Havant Thicket Reservoir

Phase 7 & 8 – Landscaping and Discharge Structures

HBC ref: App/26/00679

EHDC ref: EHDC-26-1027

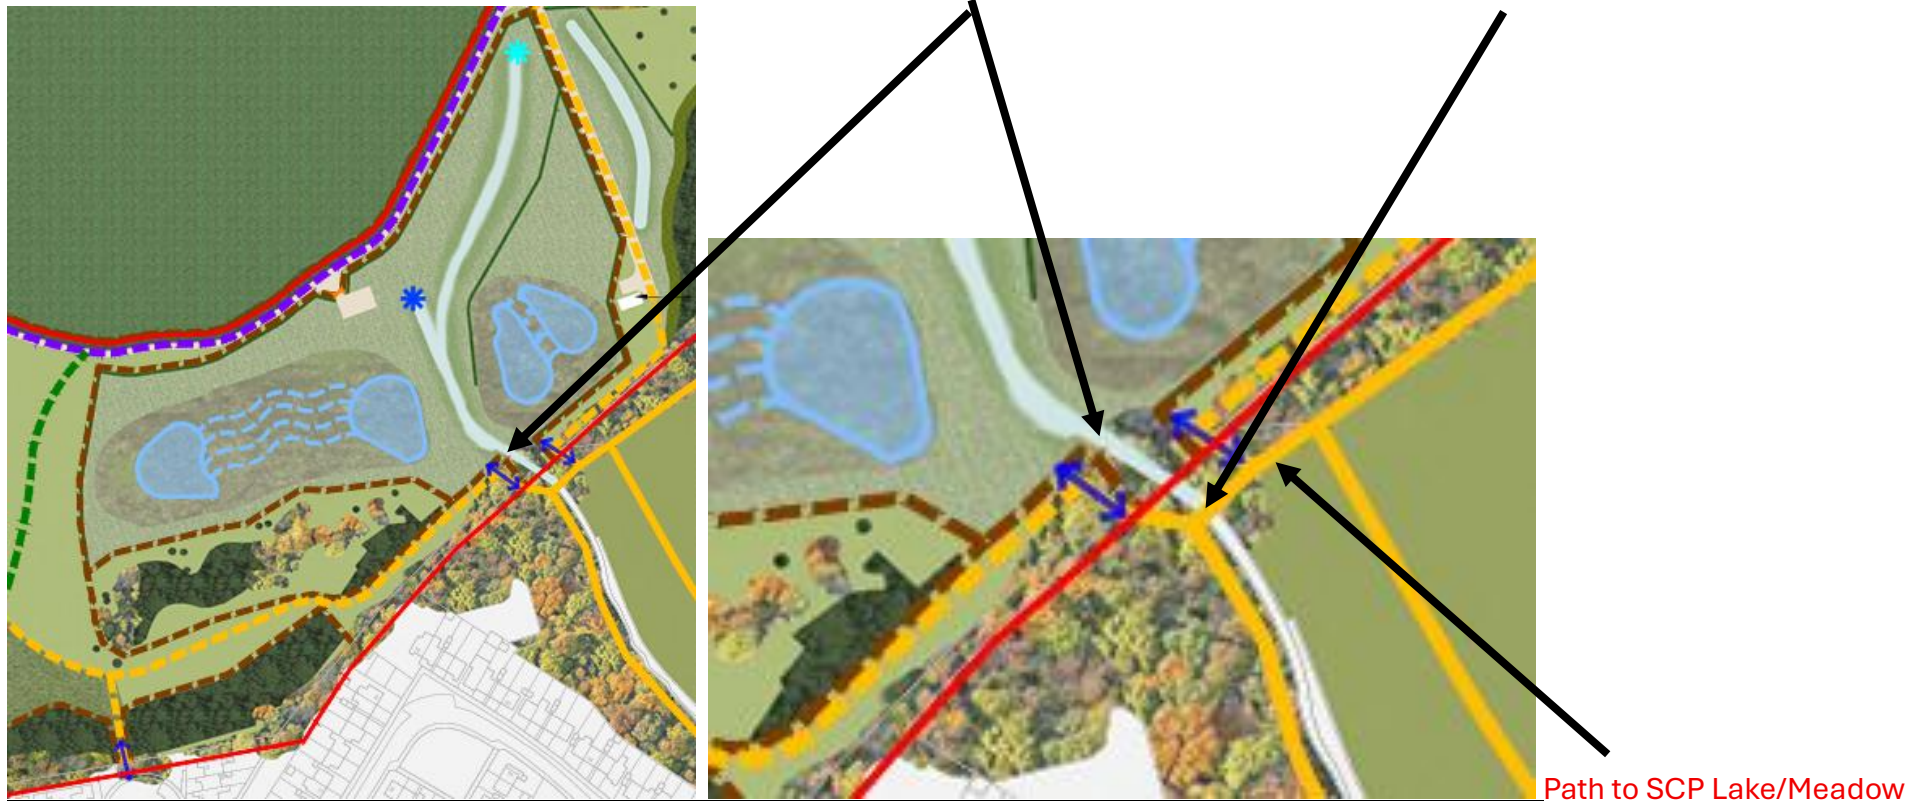
A further area of the advanced planting missing from the Amended Eastern Section drawing is the 6m wide rectangular area adjacent to where Cedar Drive enters the woodland'. Advanced tree planting was undertaken both north and south of the Durrants Stream to improve connectivity, with parkland standards also planted south of the stream which are not shown.

The advanced tree and hedgerow planting was approved in writing by both LPA's (East Hants District Council and Havant Borough Council) to enable the early establishment of new habitats, and to enhance the eastern wildlife corridor which was essential due to the loss of The Avenue woodland corridor. The planting is integral to the scheme and must be retained and maintained in future by the applicant. The missing areas of advanced planting and hedgerows must be added to the Phase 8 drawings before the application is approved.

Extract of workshop presentation slide – Operational details (extract) -pdf page 39 (Statement of Community Involvement) shows the alignment of the pipes between the Control House and Round Wood

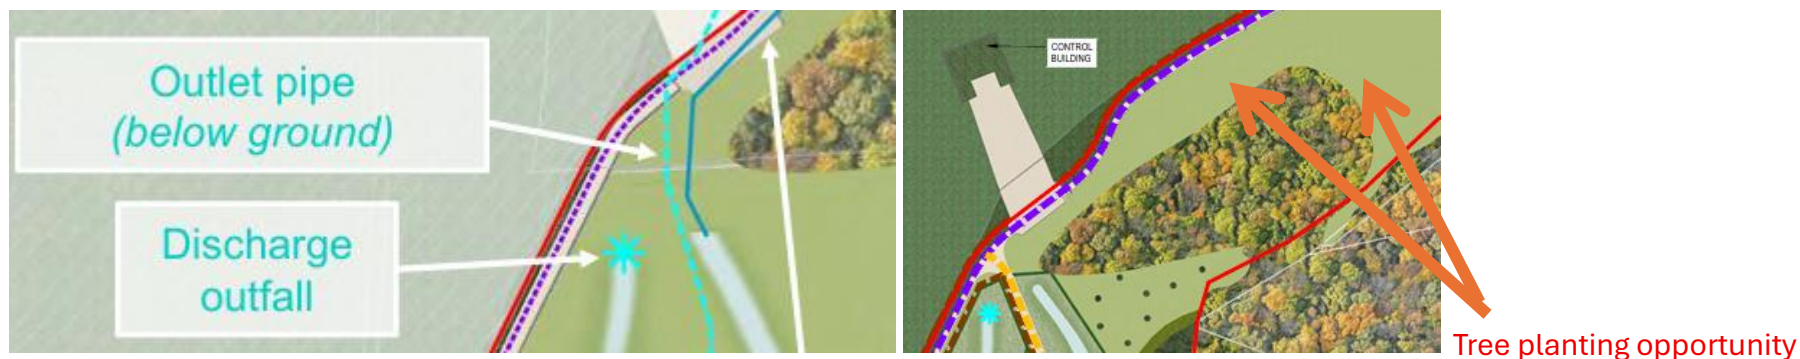
There should be space to plant trees immediately to the NE and east of Round Wood (see orange arrows) to restore ancient woodland and create a transitional edge habitat that would be beneficial for wildlife and create a more natural graded landscape, while avoiding the underground pipework. The LPA should request that the applicant give this further consideration.

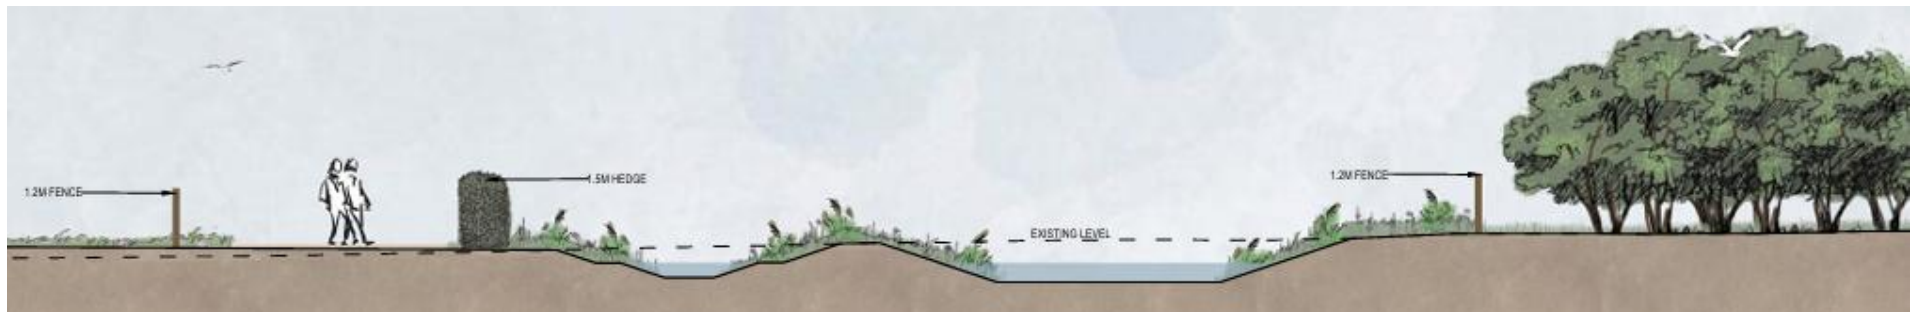
There is also reference on the sections to existing advanced planting areas which are currently protected by 1.8m high deer fences with stockmesh **being replaced by 1.2m fences**. For example, REALIGNED DURRANTS STREAM CROSS SECTIONS R52-R52' extract below shows the Gipsies Plain Phase 1 woodland corridor protected by a 1.2m fence, not the existing 1.8m deer fence.

The existing deer fences protecting the advanced planted areas should only be replaced when they are at the end of their useful life and the trees within are well established. Despite construction activities deer are still present at the site, 2 were seen just outside deer fenced advanced planted areas on 7/10/26, and deer will quickly re-establish in larger numbers once the construction work is complete. Planted areas must be protected from deer grazing to enable the trees to establish.

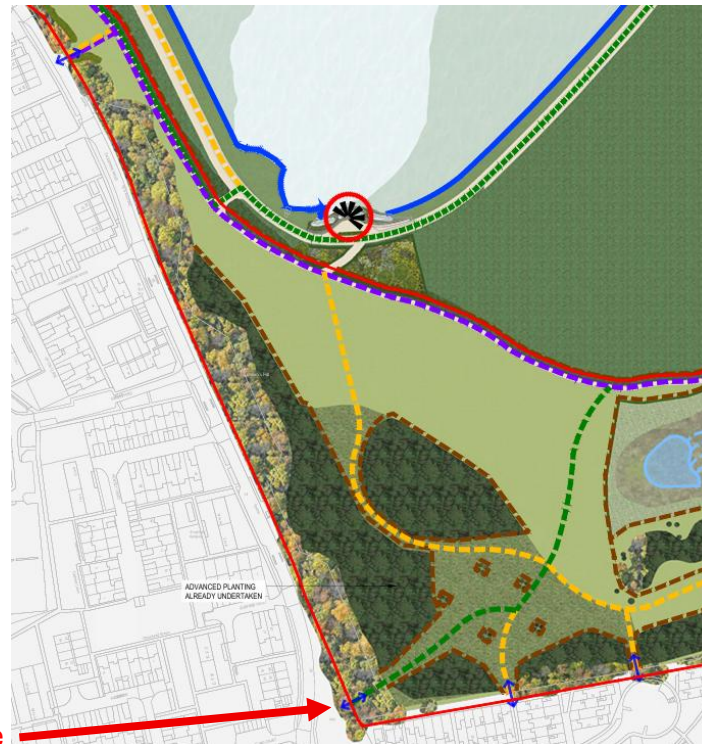
While it is acknowledged that control of access is a difficult balancing act with competing priorities, the area of the reservoir site has a very long history of unauthorised motorcycle use resulting in damage to habitats, health & safety risks and anti-social behaviour. Excellent provision for disabled and family access will be provided in the NW area of the reservoir site (the hub for visitor activities). **Barriers to restrict motorcycle access to the reservoir site must be a priority.**

Instead, it is proposed that a planning condition is attached the Phase 7 & 8 RMA requiring the details of access management measures at entrances to the site where not included on the approved drawings to be submitted to and approved by the local planning authority prior to the reservoir site opening to the public. This will enable the final approach to be informed by the outcome of further stakeholder discussions and equality considerations, including compliance with the Equality Act 2010, and ensure there is alignment with the reservoir-wide Recreation and Access Strategy.
